NOTICE OF VIOLATION

INSPECTION REPORT

Electrical Corporation:	Pacific Gas and Electric Company				
Report Number:	CAD_PGE_LOK_20240822_1116				
Inspector:	Lovepreet Kaur				
WMP Year Inspected:	2024				
Quarterly Data Report (QDR) Referenced:	Quarter 1 (Q1)				
Inspection Selection:	Energy Safety viewed the contents of the Q1 QDR and performed an analysis that resulted in the selection of				
	the WMP initiatives and locations referenced in this report.				
Relevant WMP Initiative(s):	8.1.2.10.5 - Non-Exempt Expulsion Fuses				
Date of inspection:	August 22, 2024				
City and/or County of Inspection:	Oroville, Butte County				
Inspection Purpose:	Assess the accuracy of Pacific Gas and Electric Company's QDR data, completeness of its work, compliance				
	with WMP requirements, and compliance with its protocols.

Item1IA1Img1: View of non-exempt expulsion fuses

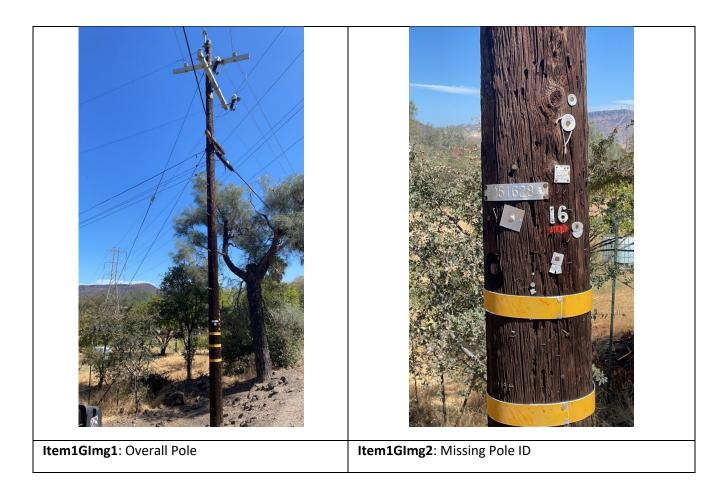
On a pole with an unknown Pole ID, Grid Hardening ID 31658324, at 2-98 Bo-y-le Ln, Oroville, CA, 95966, USA, 39.52488273963509, -121.5368588287372, the inspector observed non-exempt expulsion fuses that PG&E reported were replaced. The inspector's observation is documented in Violation 1 photographs, which are attachments to this report. Photo numbers Item1GImg1, Item1GImg2, and Item1IA1Img1 depict non-exempt expulsion fuses that were not replaced with CALFIRE-exempt expulsion fuses.

- 1. Pacific Gas and Electric Company reported that WMP initiative 8.1.2.10.5 Non-Exempt Expulsion Fuse Replacement was completed at this location.
- 2. Non-exempt expulsion fuses were observed at this location.
- 3. Non-exempt expulsion fuses (8.1.2.10.5) were not replaced with CALFIRE-exempt expulsion fuses.
